MIL-R-39017E
AMENDMENT 4
7 March 1996
SUPERSEDING
AMENDMENT 3
3 October 1994

MILITARY SPECIFICATION
RESISTORS, FIXED, FILM (INSULATED)
ESTABLISHED RELIABILITY,
GENERAL SPECIFICATION FOR

This amendment forms a part of MIL-R-39017E, dated 19 March 1991,
and is approved for use by all Departments and Agencies of the
Department of Defense.

FIGURE 1. Solderability requirements. "

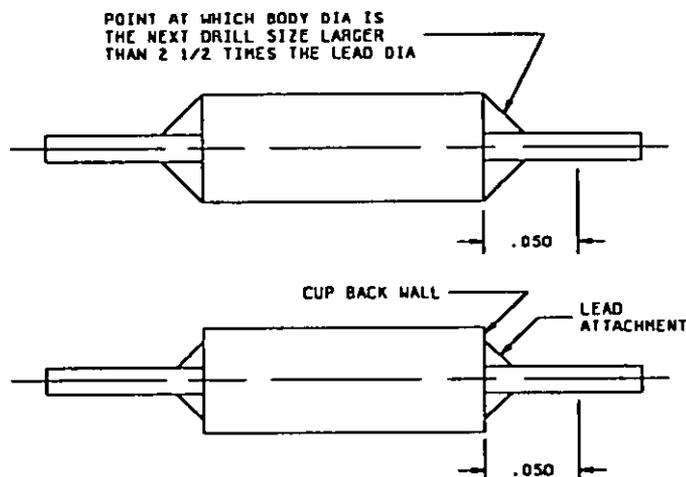
FIGURE 1, delete and substitute the following:

NOTE: Exposed copper or base metal due to lead attachment within .050 (1.27 mm) of the resistor body shall not be considered a reliability problem .
